Construction Certificate Determination

Certificate No. 2005/609

PREMISES - AVALON GOLF CLUB, BARRENJOEY ROAD, AVALON APPLICANT - VICKI JELLIS

DISABILITY ACCESS PROVISIONS IN PROPOSED ALTERATIONS & ADDITIONS AT AVALON GOLF CLUB

A1C	Upper Ground Floor Plan	amended 10.12 04
A2C	Lower Ground Floor Plan	amended 10.12 04
A3B	Elevations and Sections	amended 10.12 04

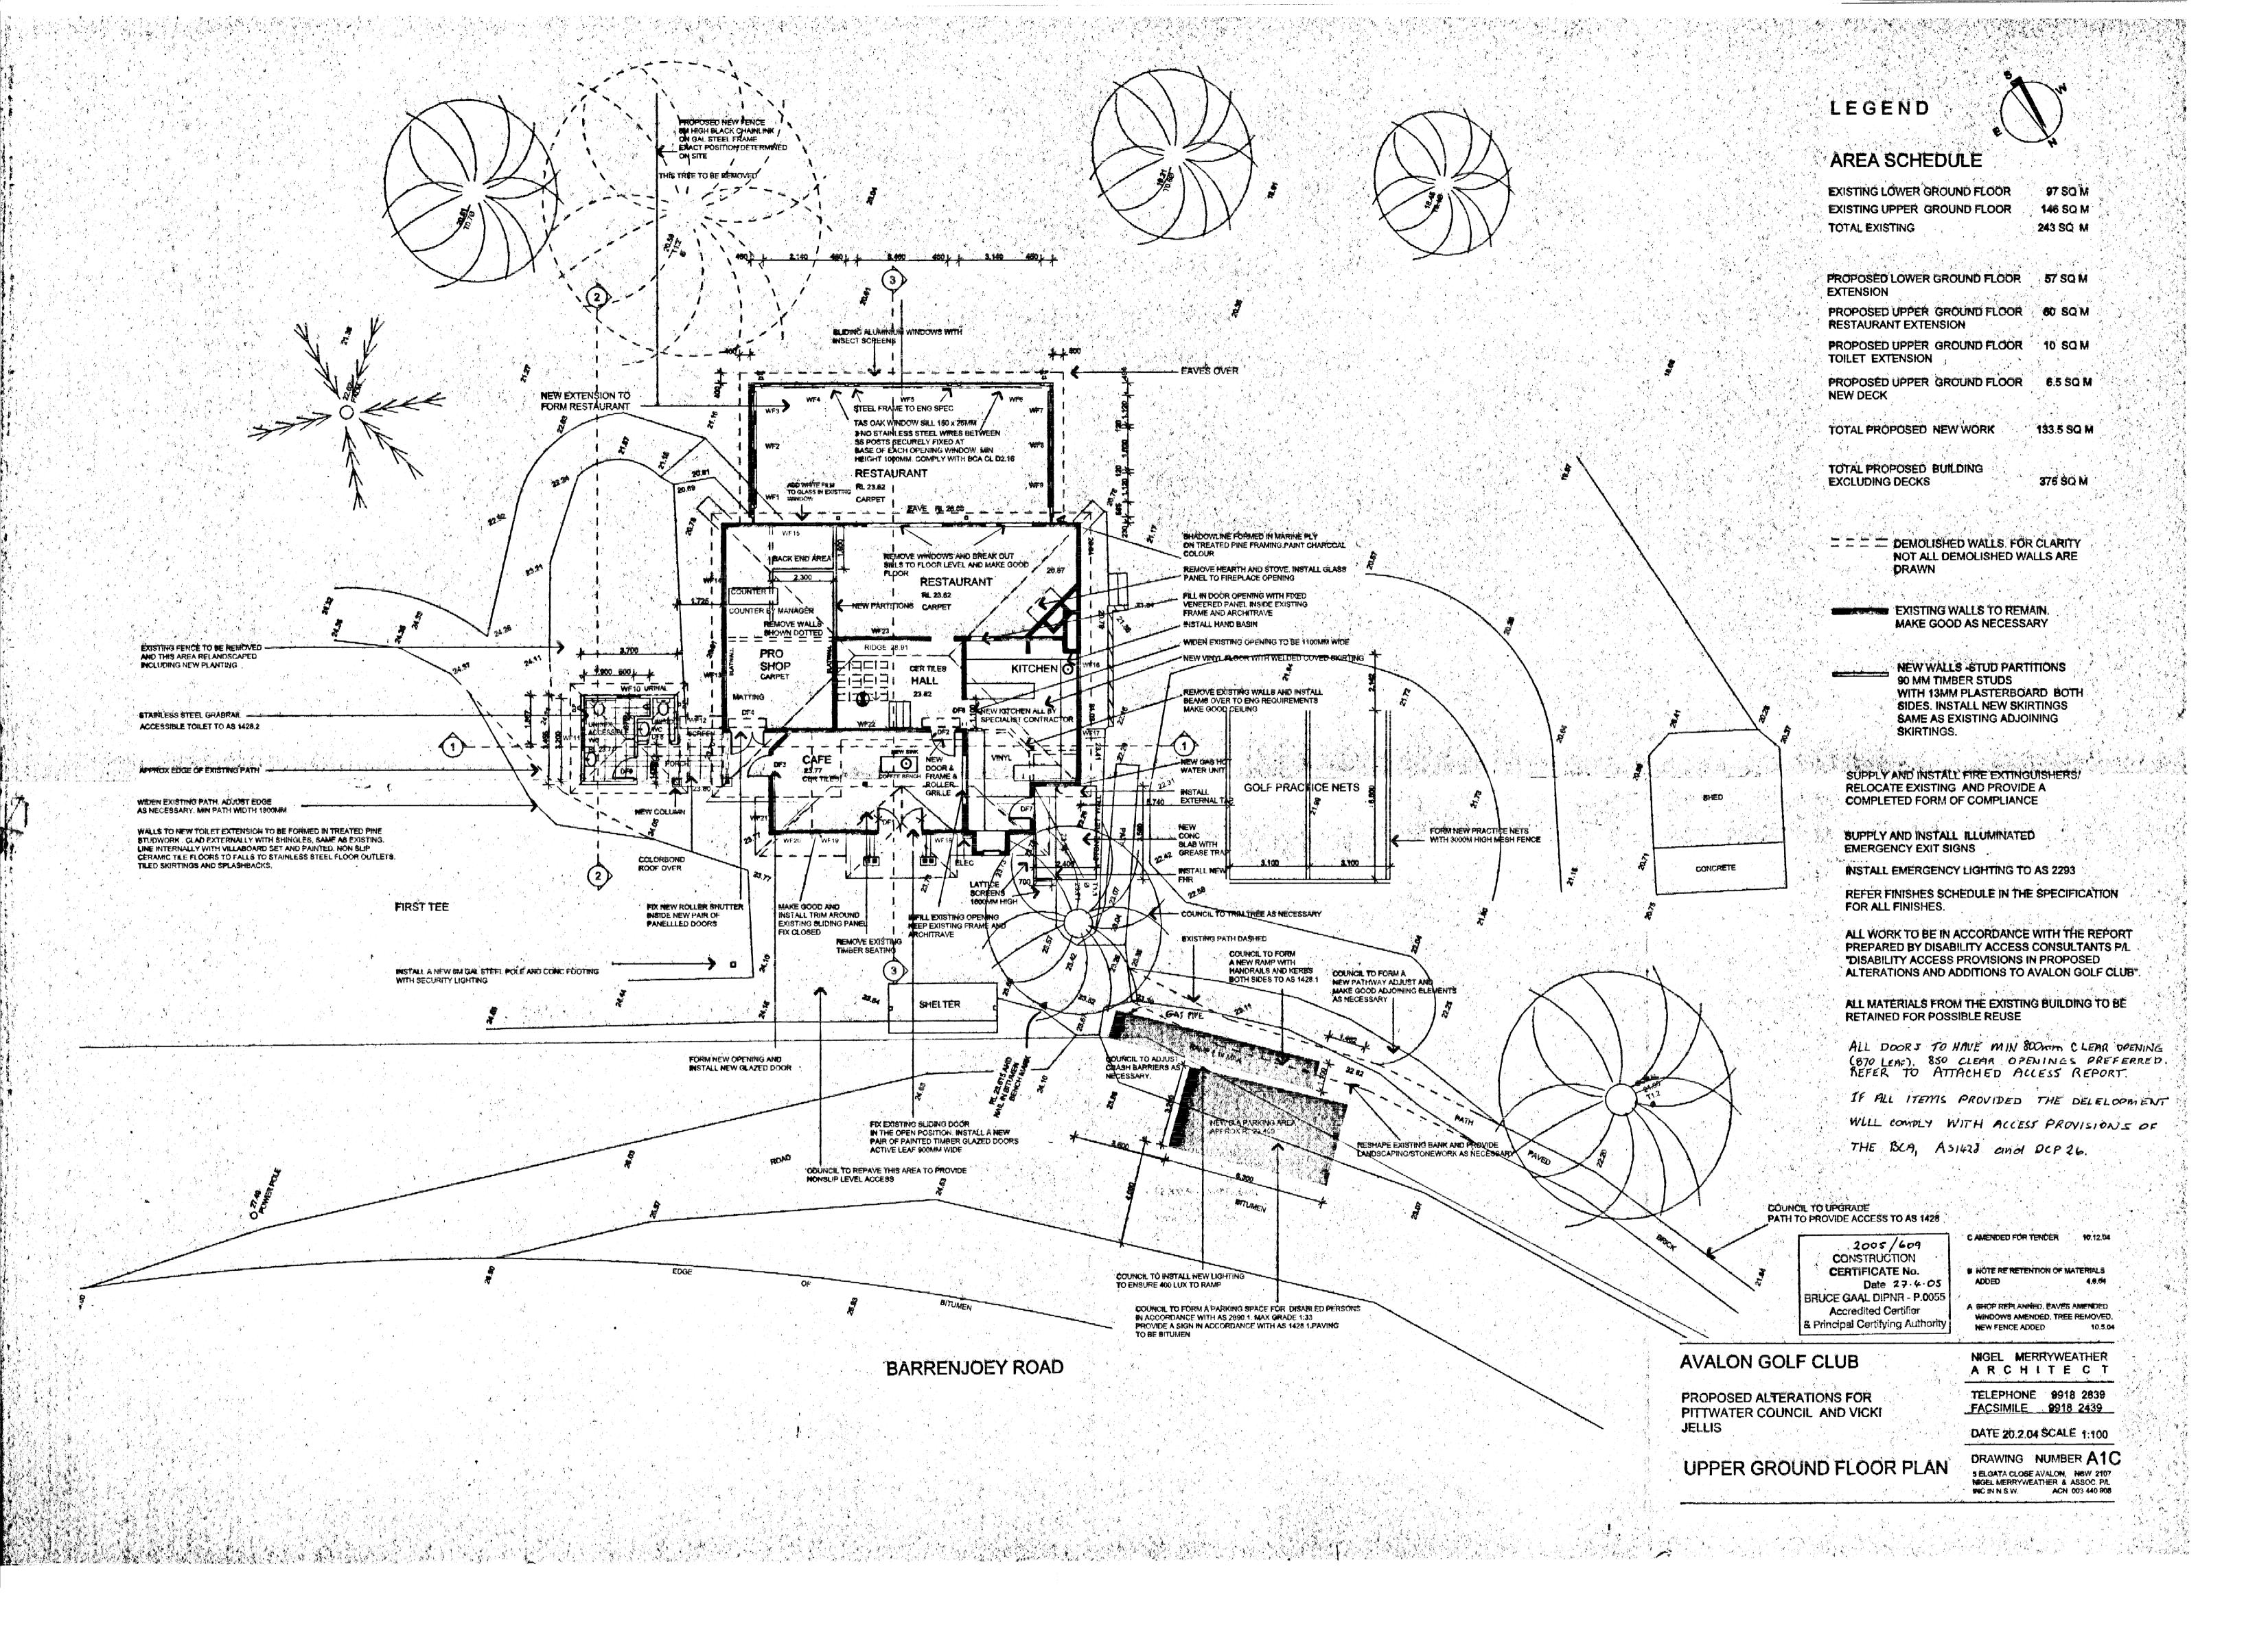
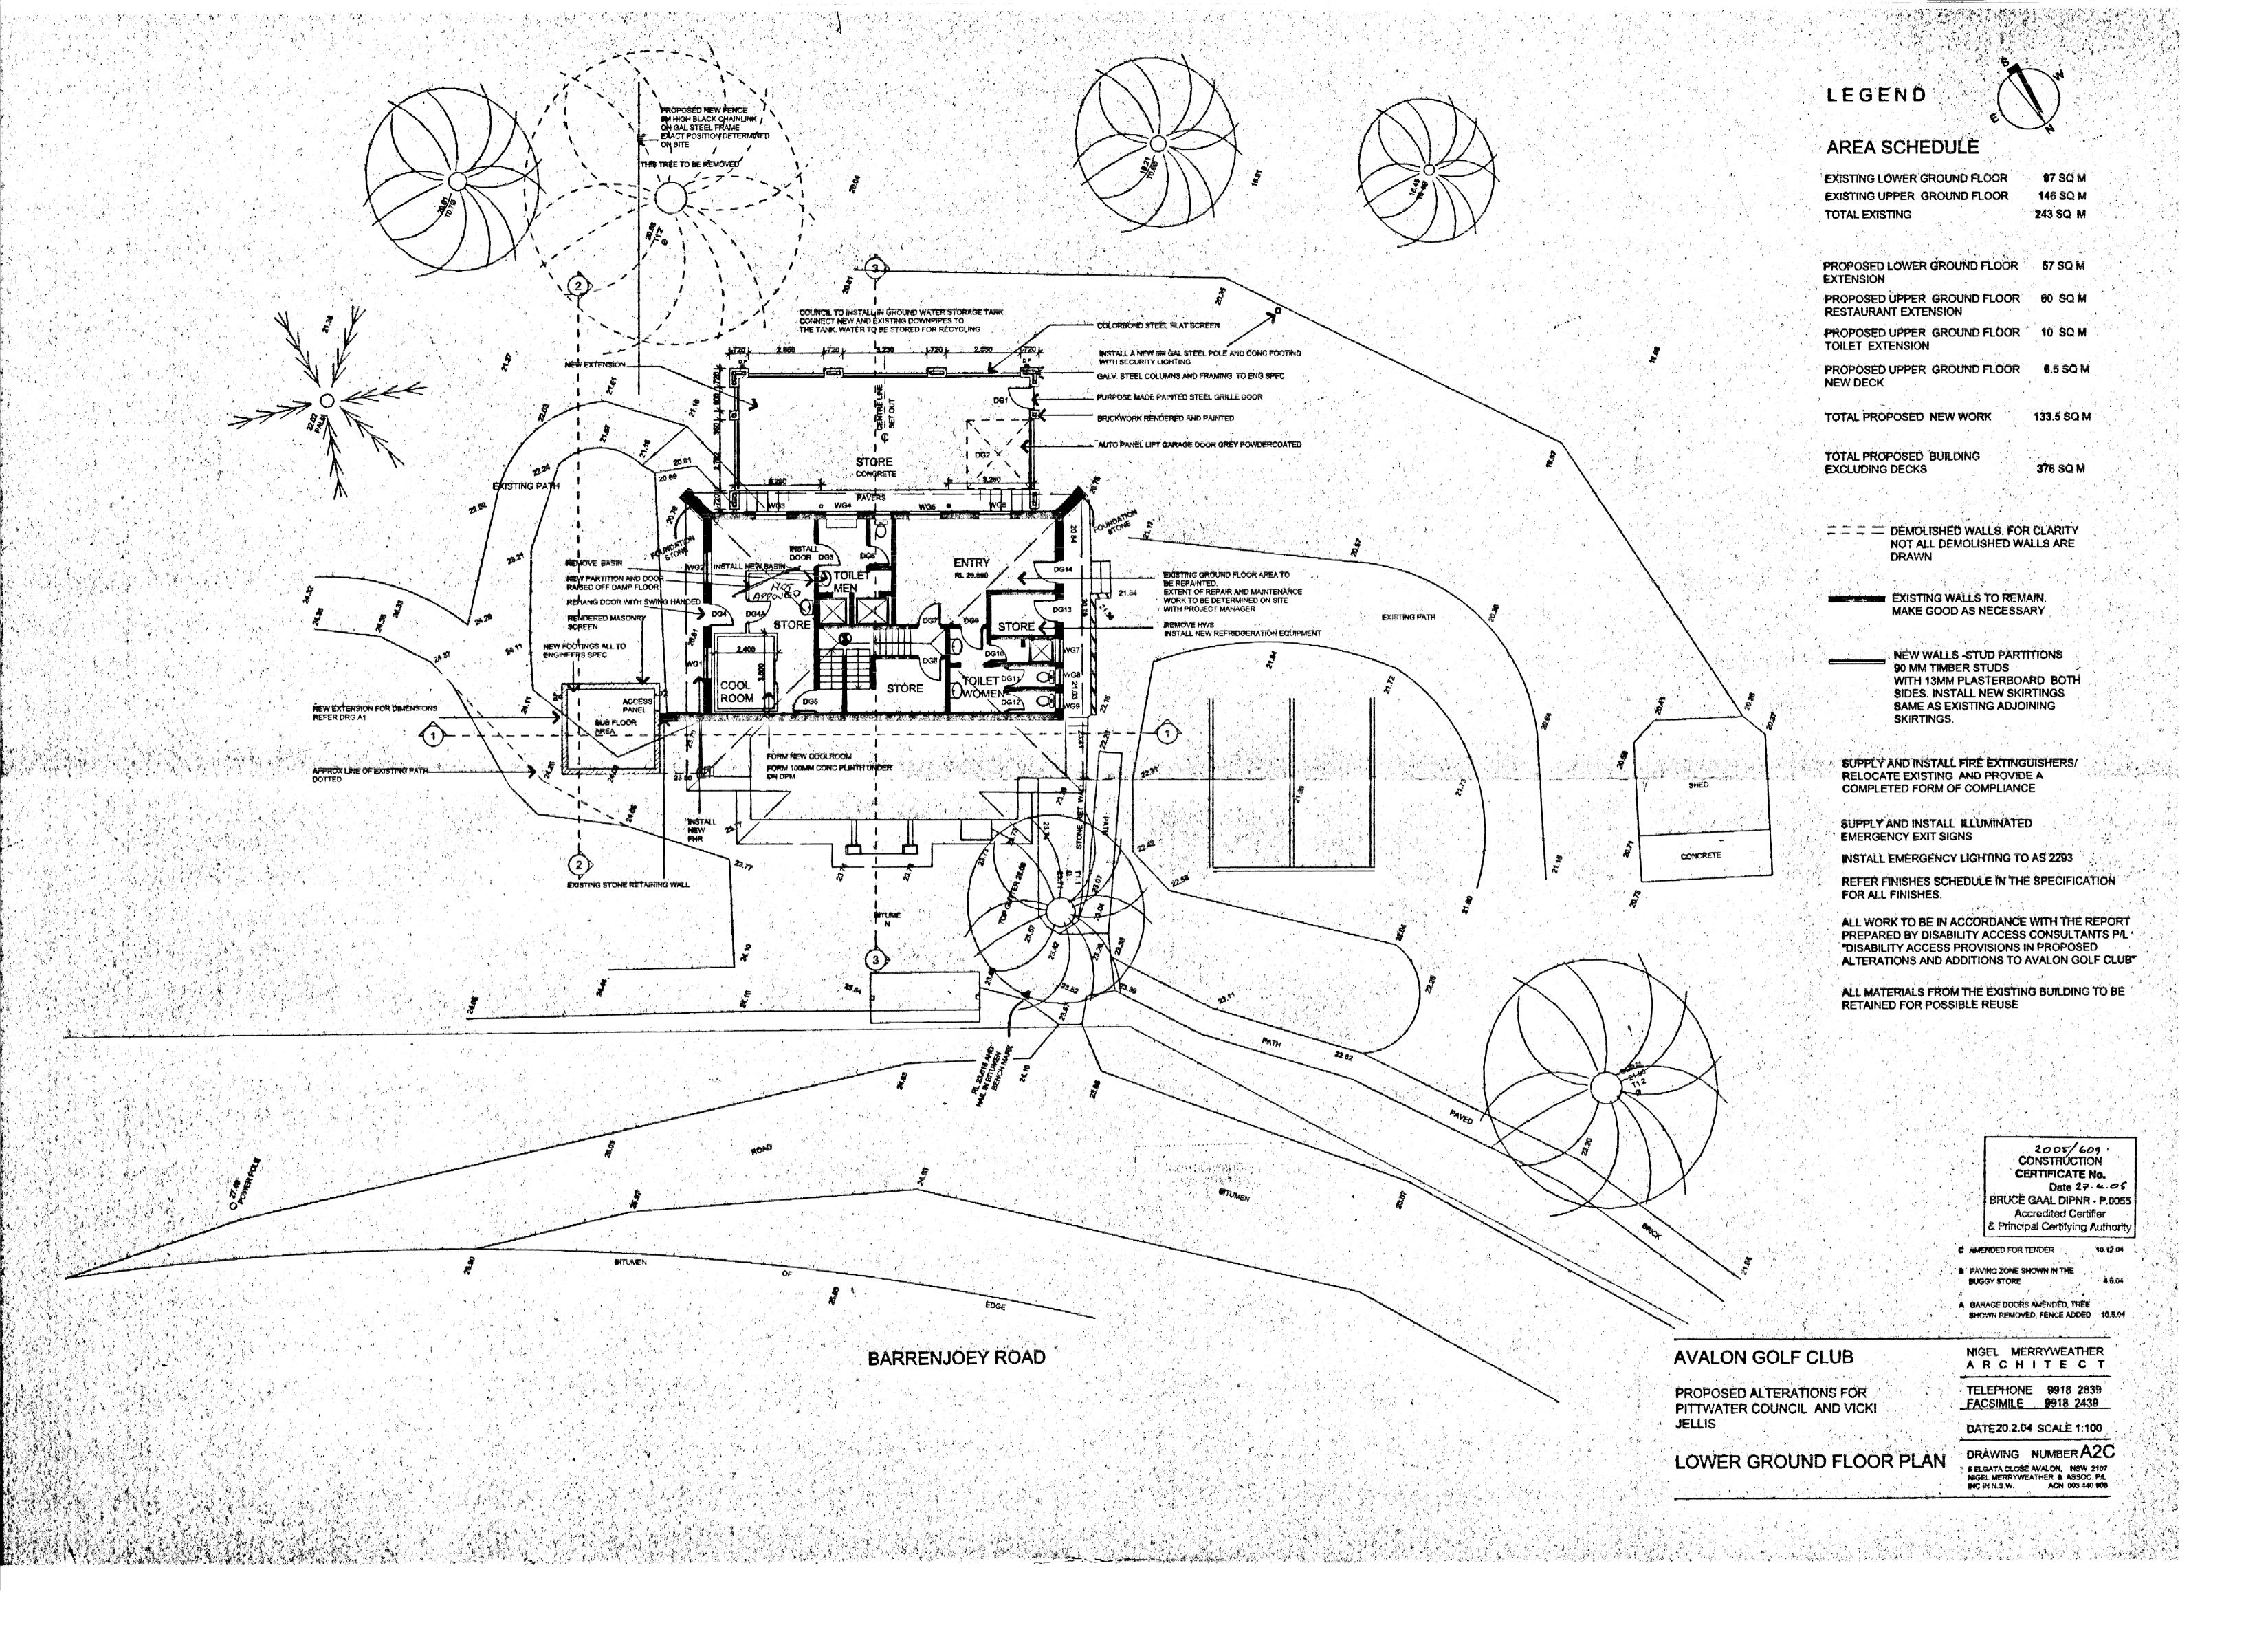
- 1. There is no detail of levels in the accessible parking space although the notes associated with the car space if followed will result in a compliant car space.

- 2. There is no detail provided for the ramp adjacent to the accessible car space, however the notes require compliance with AS1428.1. In particular the ramp should comply with AS1428.1 Figures 1, 2, 3 and 9 and clauses 5.3, 5.4, 5.7 and 6.1.

- 3. The path of travel from the ramp into the premises is not illustrated and can not exceed 1:20 gradient. The existing levels indicate that a path will comply.

- 4. We are not in possession of the door schedule however we note that a minimum clear opening of 800mm is mandatory (870mm leaf) and HREOC suggests a minimum of 850 clear opening (920mm door leaf). The door circulation spaces of AS1428.1 Figure 12 appear to have been provided.

- 5. The minimum lighting level along the accessible paths of travel should be no less than 150 lux together with the 400 lux nominated at the ramp.
- 6. The continuous accessible paths of travel within the site from the accessible parking space to the clubhouse and from the clubhouse to the sanitary facility must have no level differences between adjoining surfaces greater than 3mm or 5mm where rounded. The surface of the pathway must be slip resistant to at least AS/NZS 4586. If weathering is required at the entries then a threshold ramp 35mm high at 1:8 gradient and 280mm wide measured outwards from the face of the door, may be used.

- 7. All doors should have a 30% luminance contrast with the surrounding wall surface or with an architrave at least 45mm wide. Door furniture should also have a 30% luminance contrast with the door.

- 8. Glazed doors and side lights are to have a transom or a line 75mm wide between 900mm and 1000mm high with a luminance contrast of 30% with the background against which it is viewed.

- 9. Door handles must be of the "D" lever type mounted between 900mm to 1100mm having a 30% luminance contrast with the door.
- 10. The counter bench top opening off the kitchen is to have a section at least 820mm wide at a height of 850mm +/- 20.

- 11. Light switches, intercommunication systems, access controls and the like are to be at a height between 900mm and 1100mm and no closer than 500mm from a return wall or obstruction.

- 12. The path of travel to both of the unisex sanitary facilities should be weather protected from the clubhouse entry point to the toilet facilities. We note the proposal has a glazed screen on one side only and suggest that the opposite side of the covered walkway should also be weather protected when required, perhaps with a roll down clear plastic blind for use in inclement weather only. The glazed screen is to have a transom or a solid line 75mm wide between 900mm and 1000mm high with a luminance contrast of 30% with the background against which it is viewed.

- 13. As drawn the unisex accessible sanitary complies with the requirements of AS1428.1 except that the WC does not appear to be an accessible pan, ie 800mm +/- 10mm from the front of the pan to the wall behind and 450mm 460mm from the centre line to the wall beside.

- With a minor relocation of the handbasin so that there is a minimum of 2200mm from the edge of the handbasin to the wall behind the WC and a minimum of 425mm from the centre line of the handbasin to the adjacent side wall, it would comply with AS1428.2.

- 14. The door handle is to be of the "D" lever type on both sides mounted at 1000mm and the indicator locking mechanism is to be of the large lever type also. The light switch is to be of the large rocker type (35mm or similar rocker) mounted at the latch side of the door 1000mm above floor level. The door is to be of the self closing type but preferably with rising butt hinges and not with a door closer. After hours locking must use the Master Locksmith Access Key (MLAK) system.

- 15. Lighting level within both of the toilet facilities must be a minimum of 200 lux.
- 16. Ensure that the walkway area has a lighting level of no less than 150 lux.

- 17. Signage for the toilets must be in accordance with the BCA provisions and for the accessible facility be raised tactile male & female and access symbols in white on an ultramarine blue background with Braille equivalent wording. Similarly the signage on the non accessible unisex facility is to be raised tactile male and female with Braille equivalent wording but without the symbol of access. Both should have 30%
